2315084-1 - Hippo Motor Group  
Administrator: LC (FA)  
Date: 15/11/2019  
Amended: 18,22/11/2019

PRODUCT: Fresh Lunch Cooler Bag - 6 Can - Purple

Option 2

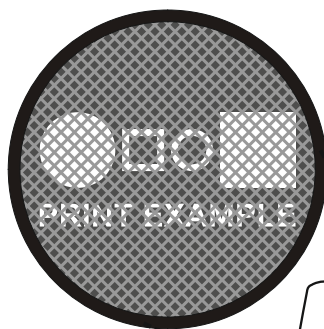
This artwork is too small to print on this surface.

Details will fill or be unreadable especially on the text for **MOTOR GROUP** and **Grizedale Stages Rally**.

It is advisable to do simpler artwork with less small text.
